Independent expert review

Water resources

Presentation to the Independent Planning Commission
Public Hearing · 17 July 2026 · Branxton Community Hall

Dr Steven Pells

Wollombi Brook alluvium - competing predictions of impacts

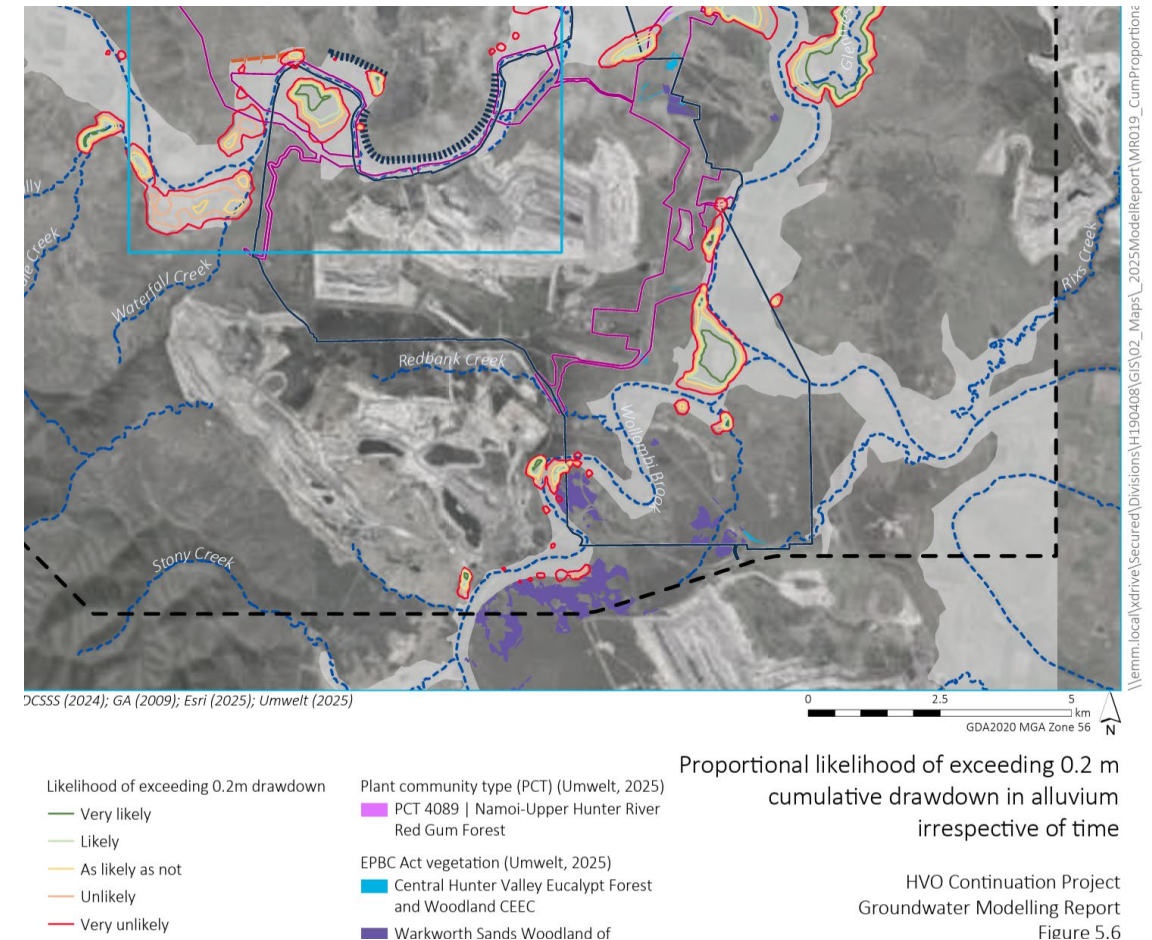
EIS (AGE 2022)

up to 5 m

Amendment (EMM 2025)

up to 2 m

Same model, same mechanism. No technical explanation offered for the reduction.

PER (EMM 2026)

no magnitude

Reported only as "minority of parameter realisations." Peak value no longer stated.

Same MODFLOW-USG model. Same domain. Same conceptual representation of Lemington Underground. Different numbers.

No numbers

The Carrington West Wing low permeability barrier wall

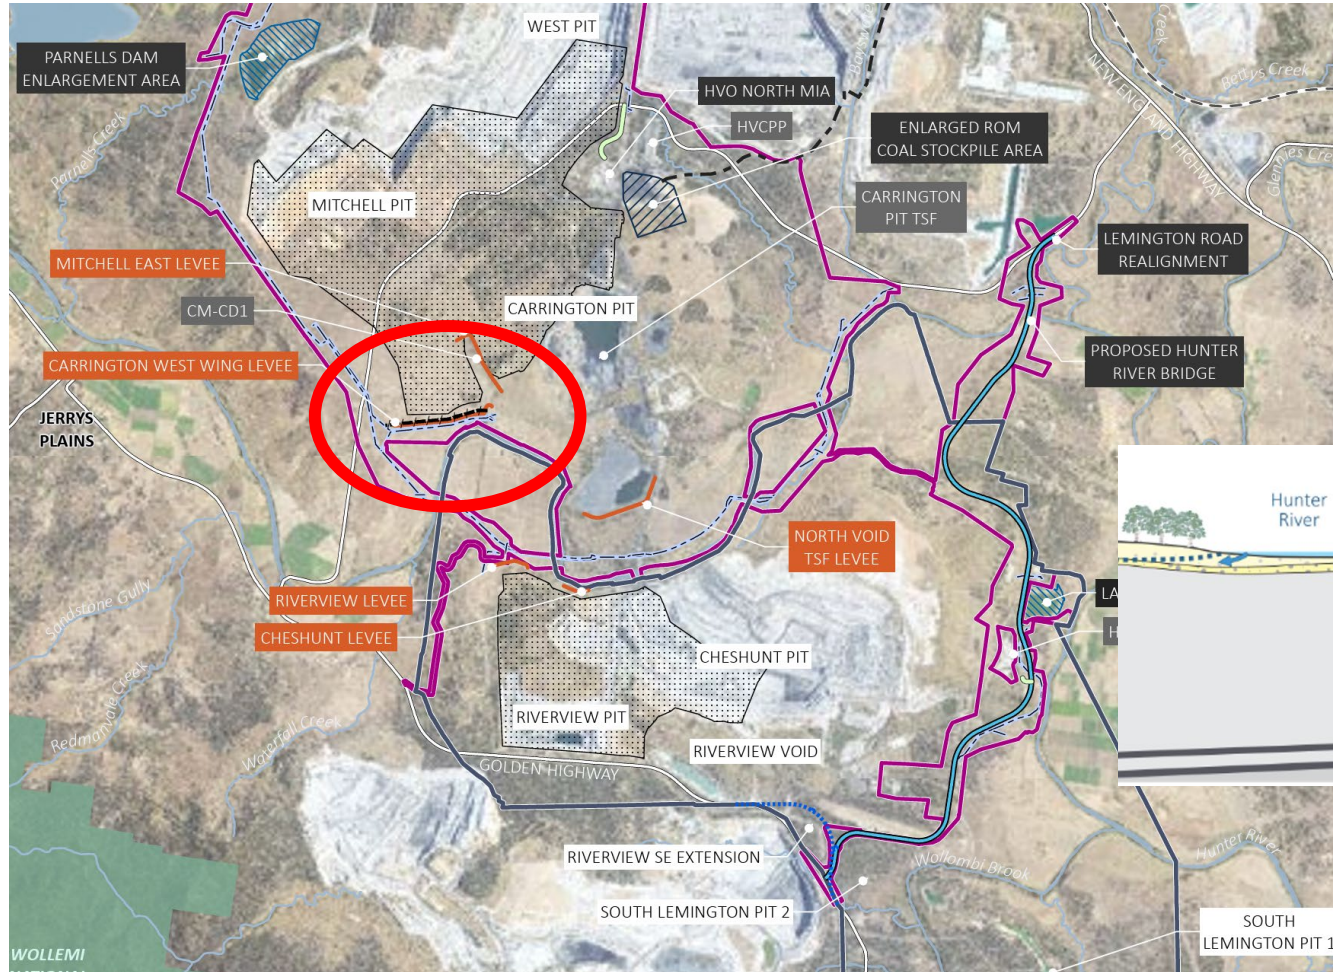
The Project's impact predictions for the Hunter River alluvium depend materially on the wall performing to a permeability of 10^{-8} m/s for centuries. The current documents specify no wall thickness, no depth, no keying detail, no verification arrangements, and no long-term monitoring plan.

What we know about the wall

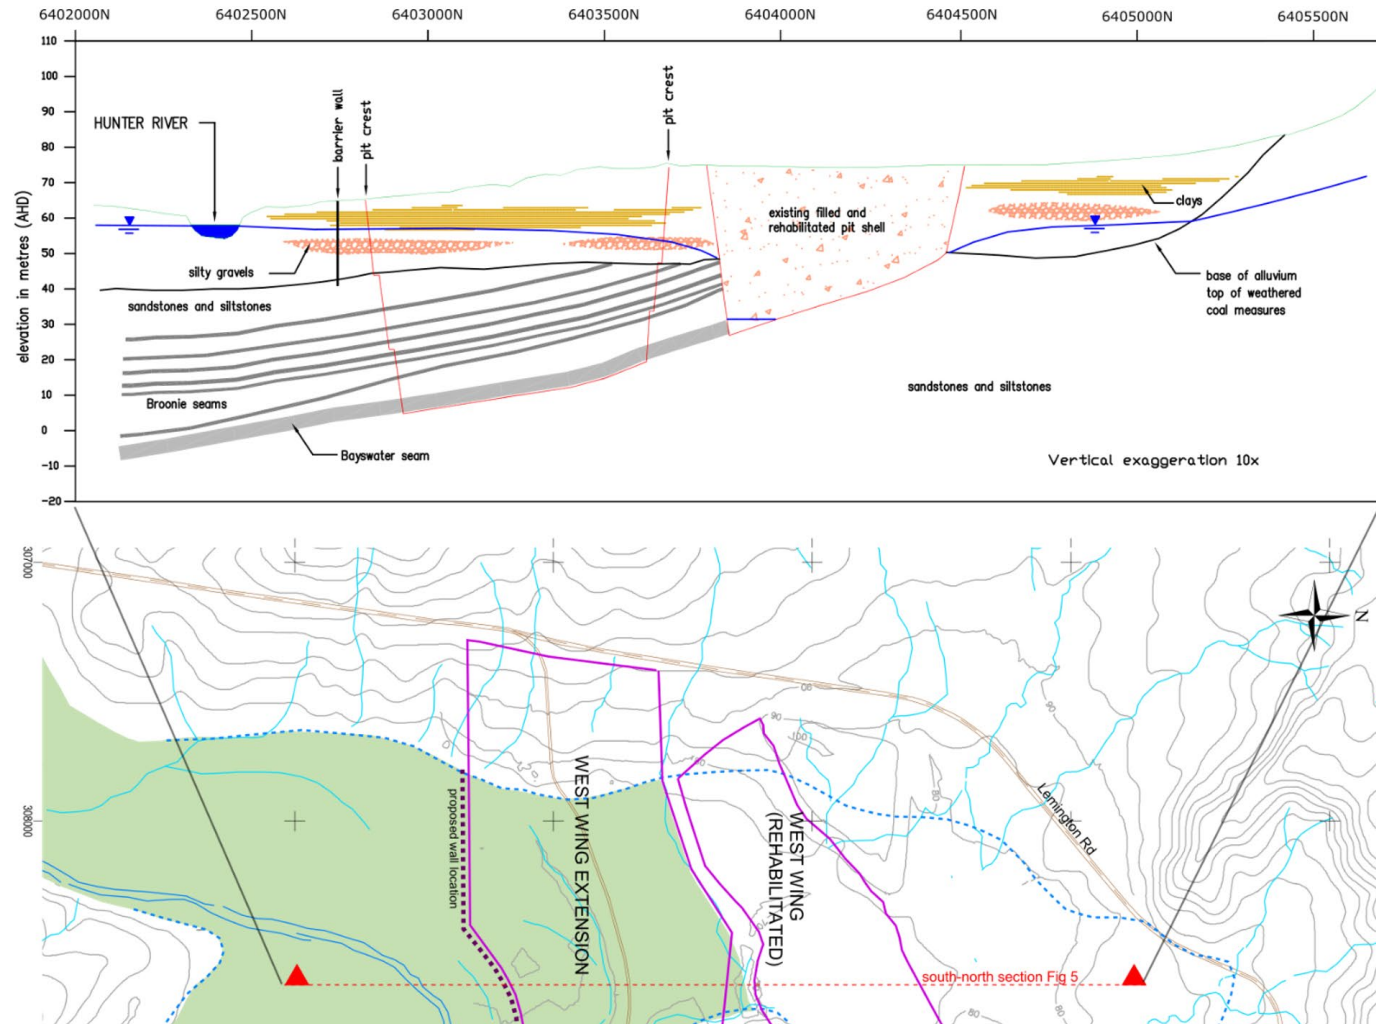
- Location in plan view
- Design permeability of 10^{-8} m/s
- “Keyed into unweathered rock”
- Constructed before mining within 100 m of the paleochannel
- As-built report and endorsement by DPI Water

Predictions depend on the wall performing to design specification.

What we must assume

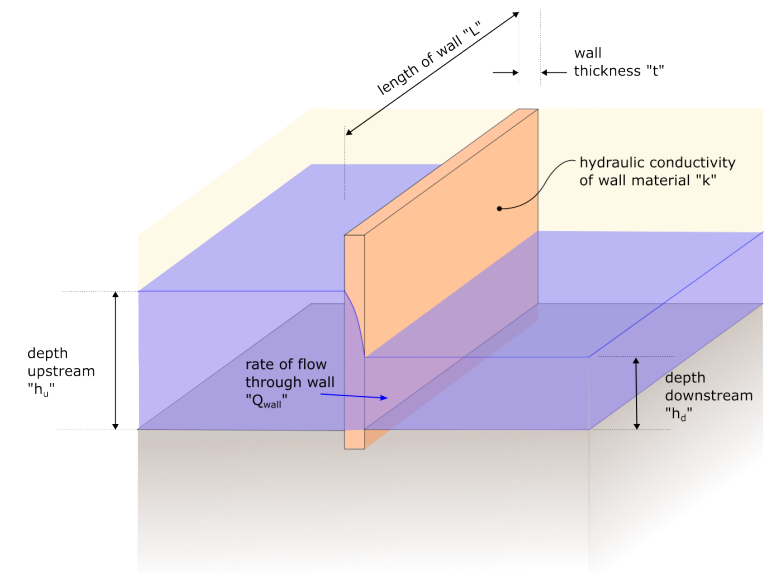
- 25m depth?
- Head differential?

The current documents do not specify:

- Wall thickness*
- Depth below the alluvium base
- Keying into unweathered rock - method and verification
- Construction materials
- Construction methodology
- Quality assurance and verification of as-built permeability
- Long-term performance monitoring program
- Trigger levels and contingency response if underperforming
- Long-term integrity and degradation to year 3000
- Sensitivity of predicted impacts to wall underperformance

* Specification of hydraulic conductivity without wall thickness is incomplete

With same hydraulic conductivity, a wall 2m thick is 10 times more effective than one 0.2m thick, and less prone to failure (its like specifying design of a mattress by saying the material to be used, but not saying how thick it should be)
